**COMMITTEE OF THE WHOLE   JUNE 18, 2001**

**ZONING BY-LAW AMENDMENT APPLICATION (REMOVAL OF HOLDING SYMBOL)  
SITE DEVELOPMENT APPLICATION  
SEVENBRIDGE DEVELOPMENTS LIMITED (HOME OUTFITTERS)  
FILES: Z.99.010 & DA.00.061**

**ATTACHMENT '3'**  
**SITE PLAN**

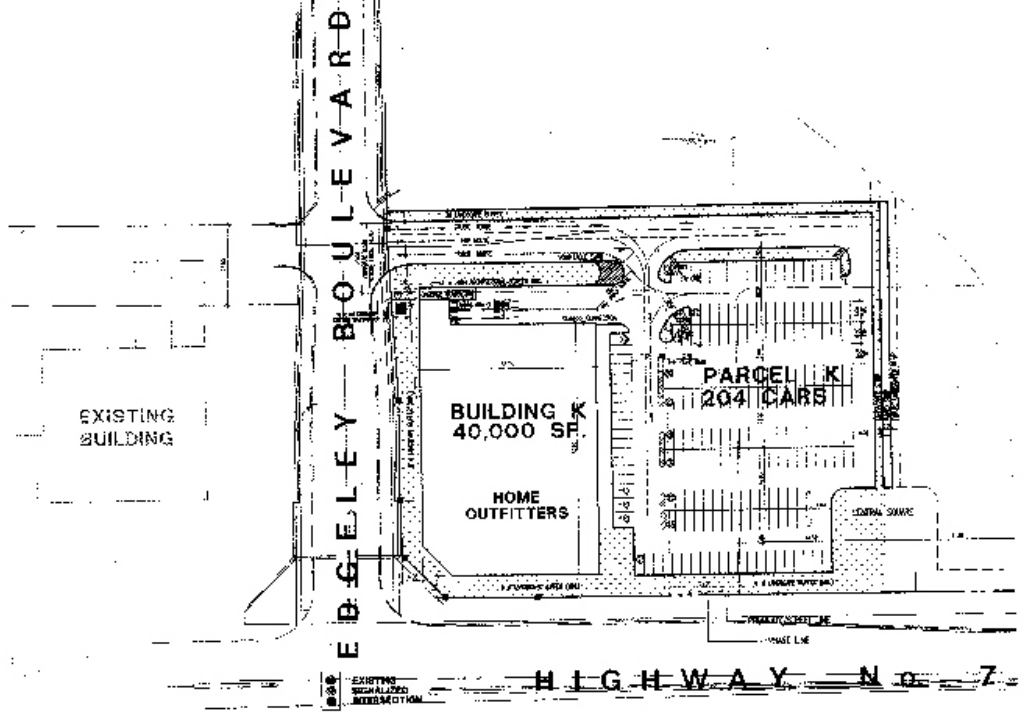
The Building Standards Department advises that the maximum driveway width at Edgeley Boulevard is 13.5m. As a measurement is not shown on the site plan, confirmation of the driveway width is required. A minimum building height of 8m is required, whereas the latest elevation drawing shows a height of 7m. The elevation drawing should be revised to meet the minimum height requirement of the by-law. All other aspects of the proposed development appear to comply with the zoning requirements of By-law 1-88.

The site plan does not clearly identify the easterly development limits of the subject lands, and should be revised accordingly. The site area shown on the site plan is 15,775 sq.m, whereas the draft reference plan, prepared by Holding & Jones Limited, indicates a site area of 15,969 sq.m. This minor discrepancy must be clarified, and the plans revised accordingly.

A full-moves access onto Edgeley Boulevard, would appear to align with the driveway and the driveway leading into the site is predominately within the future east/west right-of-way. However, screening for the loading area, and a portion of the garbage compactor, would encroach approximately 2m into the planned right-of-way. To protect the future right-of-way, there should be no encroachments of any structural elements.

Preferably, the footprint of the building could be modified to expand the building to the east along Regional Road 7 rather than encroaching on the driveway to the north. Alternatively the entire building could be shifted approximately 2m south, notwithstanding the building would then encroach into the minimum 6.0m wide landscape strip adjacent to Regional Road 7. Provided that the development will have quality design features, including an attractive building wall and a pedestrian interface along Regional Road 7, a variance to the landscape strip along Regional Road 7 from 6m to 4m may be supportable to accommodate the building encroachment.

1. The final plan and building elevations shall be in accordance with the Urban Design Guideline for the Sevenbridge lands and the City’s Vaughan Corporate Centre Urban Design Guideline.
2. It is our understanding the northern access, off Edgely Boulevard was to be designed to allow for the 20m ROW of the mid block road as delineated in OPA 528. This would include, but is not limited to, boulevard tree planting, street furniture and sidewalks in accordance with the streetscaping denoted in the above noted guidelines and City planting standards. The present layout indicates a loading area within the ROW as well as other features.

3. The building elevations were not forwarded however the footprint of the building does not appear to match that of the Draft Sevenbridge Urban Design Guidelines (UDG ). This location is a gateway to the Node and as such the design of the building and streetscape is to reflect the prominence of the corner and be pedestrian oriented.

4. The streetscaping along Edgely Boulevard does not reflect the pedestrian treatment delineated in the Draft Sevenbridge UDG; please revise this area to reflect the pedestrian zone with trees within decorative paving, tree grates, street furniture and other streetscape elements. These streetscape elements are to be indicated on the Avenue 7 frontage as well.

5. The Sevenbridge UDG presents planting along the Avenue 7 frontage and the parking lot side of the building, within the buffers and parking lot, that would serve to provide screening of the parking lot and reinforce the east side of the building visually. The site plan however reduces the planting and this should be reinstated.

6. The site plan indicates an architectural screen wall along the loading bay and garbage storage. Details are required for the screen wall. The wall must completely screen the loading and garbage zone and be constructed of the same materials as the building. Note comments herein regarding the location of this zone within the proposed ROW.
7. Indicate 2% snow storage on the plan.
8. Provide a detailed cost estimate for the hard and soft landscape elements proposed on the site plan.
9. Parkland dedication, as cash in lieu, will be required at 2% of the land area in accordance with the Planning Act if the payment has not already been made as a part of an earlier dedication. Confirmation is required from the City Legal Services Department, Real Estate Section.”

**ATTACHMENT '4'**  
**LANDSCAPE PLAN**

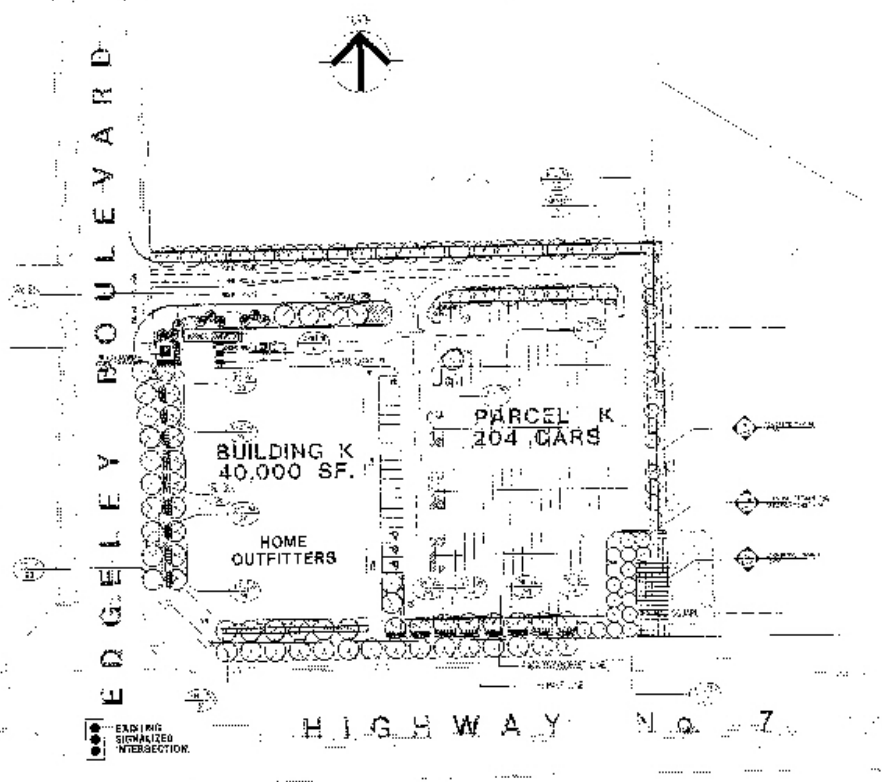
The landscape plan consists of deciduous and coniferous trees and shrubs along the perimeter of the site. Coniferous trees are provided along the screen wall. A double row of deciduous trees, combined with rows of coniferous shrubs, are proposed along Edgeley Boulevard and Regional Road 7, as identified in the proposed urban design plan/master landscape plan. One row is located within the street boulevard, external to the site. Deciduous trees are also proposed along the driveway leading into the site and along the east lot line. Lockstone paving is proposed within the central square.

The final landscape plan, including detail drawings and a cost estimate, must be to the satisfaction of the Urban Design Department and the City's Peer Review Consultant.

# ATTACHMENT '5' ELEVATIONS

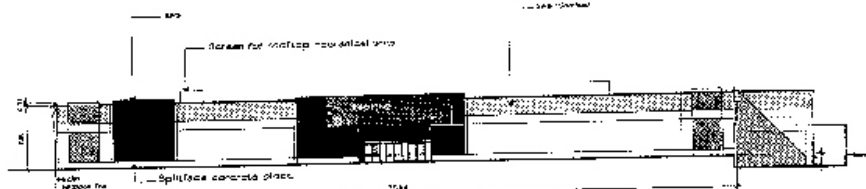
At the time of preparing this report, the Owner is having on-going discussions with the tenant regarding revisions to the building elevations shown on Attachment No. 5. The Owner has advised of the intent to revise the building elevations in accordance with the goals and objectives of the Urban Design Plan.

The current elevation drawings show a 7.0m high building with one main entrance centrally located on the east elevation. An overhead canopy and signage is proposed above the main entrance. Building materials primarily consist of white-coloured exterior insulation and finish system. Typically, stucco is applied as an exterior finishing material. The same material in a grey colour, is proposed for a cornice along the roof-line. A series of multi-coloured display panels are proposed on most elevations walls, with emphasis on the corner elevation facing the intersection of Regional Road 7 and Edegely Boulevard. The Owner proposes to screen the roof-top mechanical equipment.

It is expected that revised elevations will be submitted. The Community Planning and Urban Design Departments and the City's Peer Review Consultant must be satisfied that the final building elevations meet the design objectives of the Urban Design Plan, when approved.
